SUBMITTAL REVIEW

CLIENT NAME:	Vails Gate Fire Department		
PROJECT TITLE:	Vails Gate FD - New Firehouse		
SUBMITTAL No.:	233813-1	H2M PROJECT No.:	VGFD2001
SUBMITTAL NAME:	Kitchen Hood System SD

Product, Item, or System Submitted:	Kitchen Hood System S	hop Drawings (Phase 2)					
Submission Date:	2/28/2023	Submission Log No.:	233813-1				
Specification Section:	233813	Paragraph Reference:	1.07/A				
Contract Drawing Reference(s):							
Manufacturer's Name:							
Manufacturer's Mailing Address:							
Manufacturer's Contact Information:	Name	() Tel. no.	Email				
Supplier's Name:	Joe Lombardo Plumbino	g & Heating					
Supplier's Mailing Address:							
Supplier's Contact Information:	Name	() Tel. no.	Email				
This item is a substit item:	ution for the specified	No	Yes				
	ION SERVICES, LLC	Contractor's Brief Co (attach separate lette					
SUBJECT TO ARCHITECT AN	eptance Only. This review intractors or Suppliers of e work conform to the ct. The Subcontractor and or all dimensions, correct with the work of other trades. ID OR ENGINEER APPROVAL Ledi(PM) Date: 2/28/2023	By making this submission, we represent that we have determined and verified all field measurements and dimensio

DUCTWORK #1 TOP VIEW

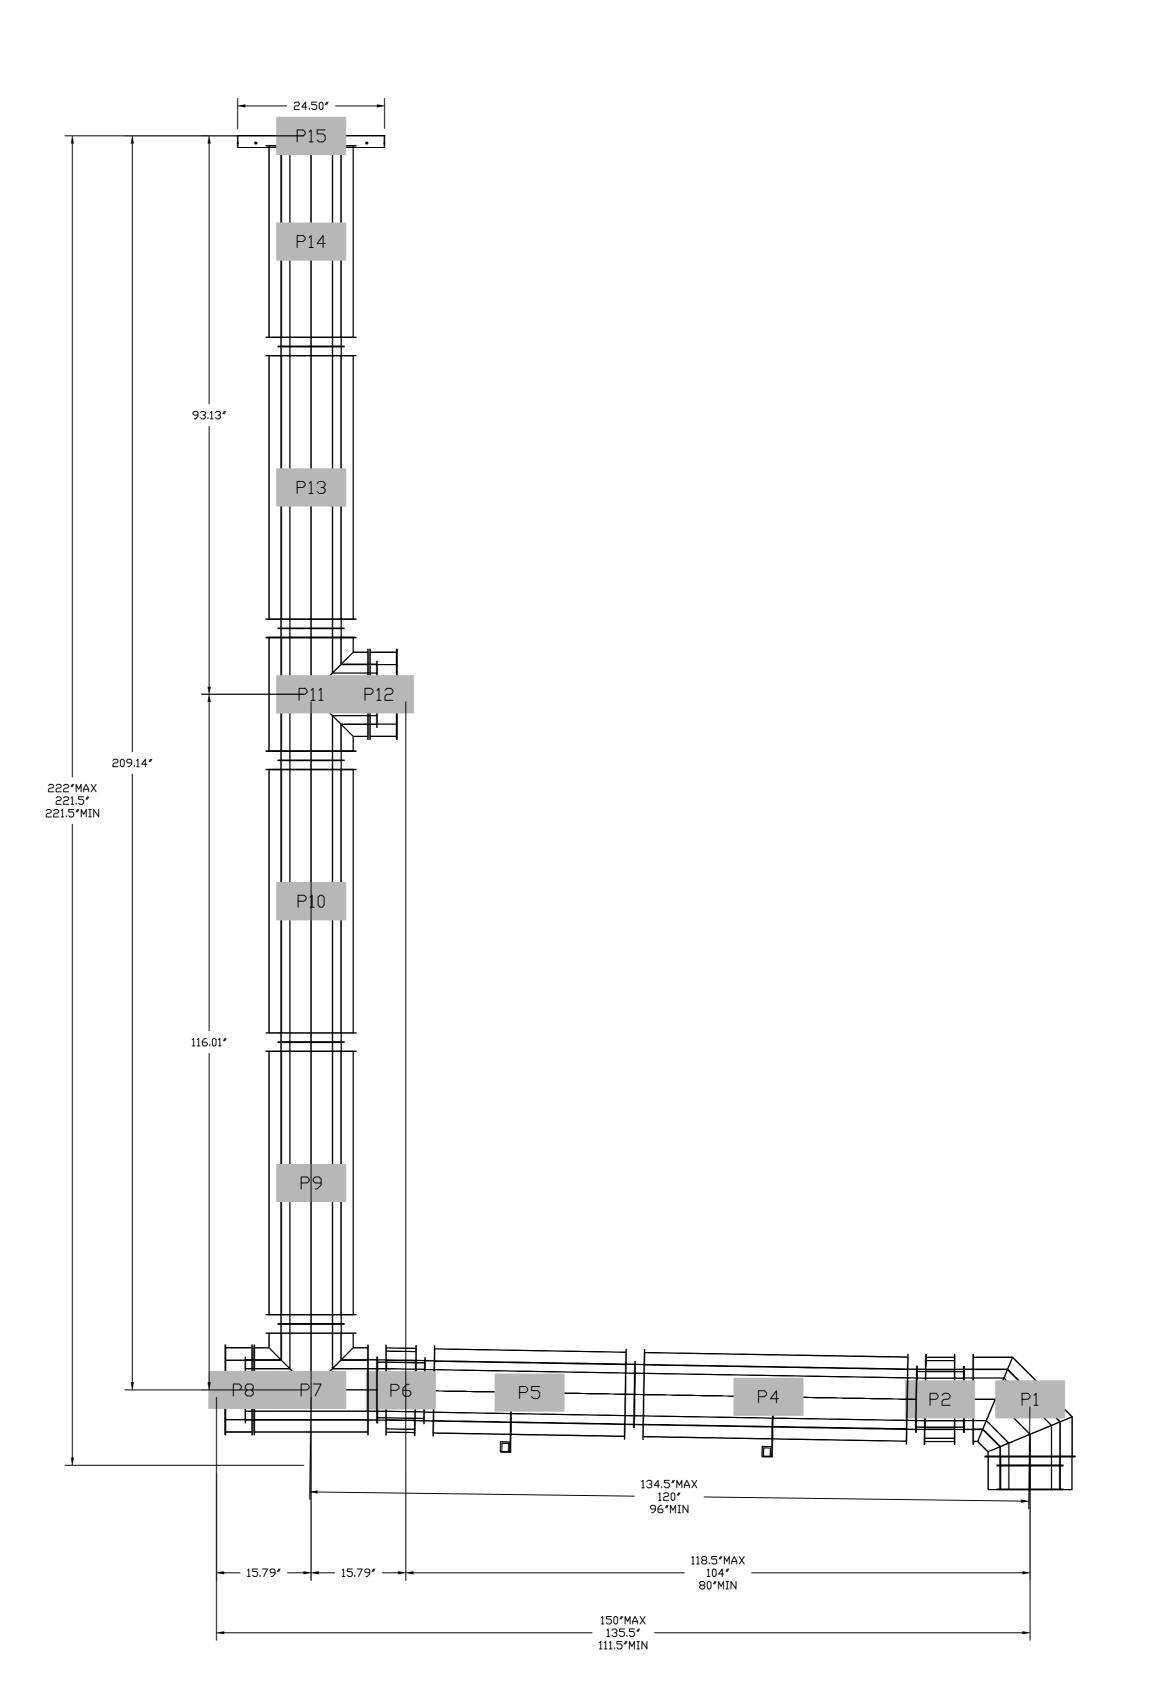
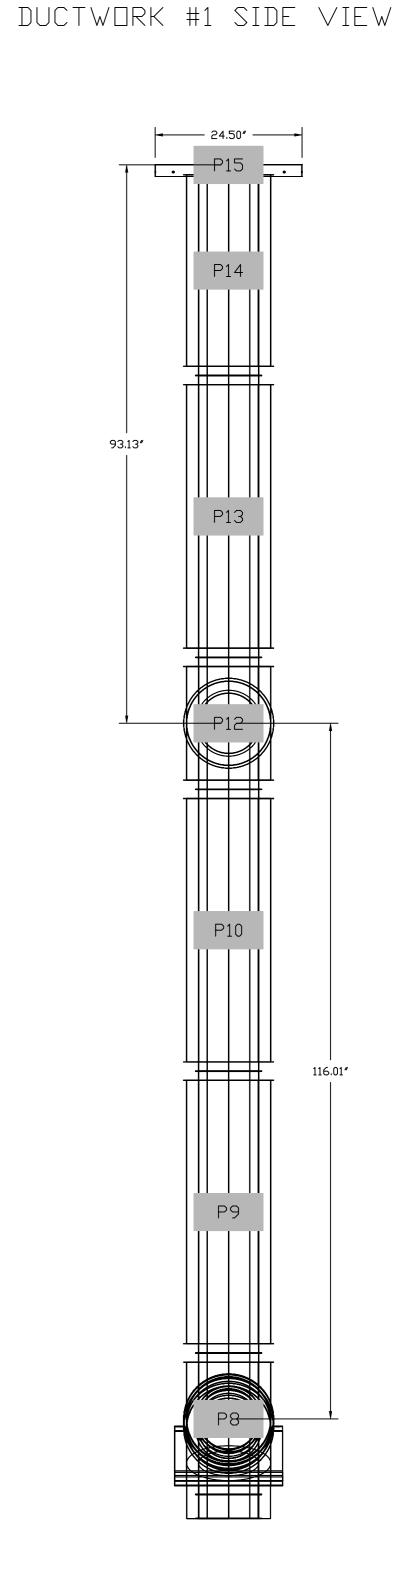
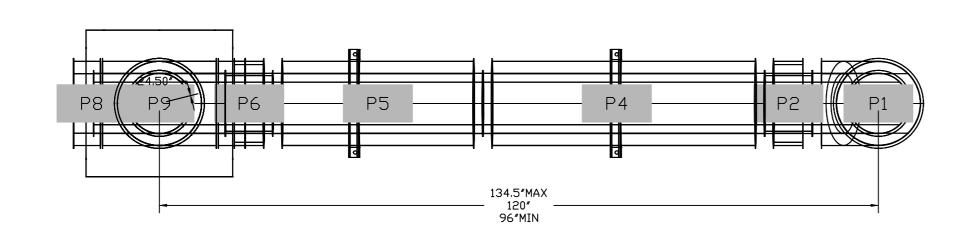
Contractor to provide leak testing in accordance with specifications.
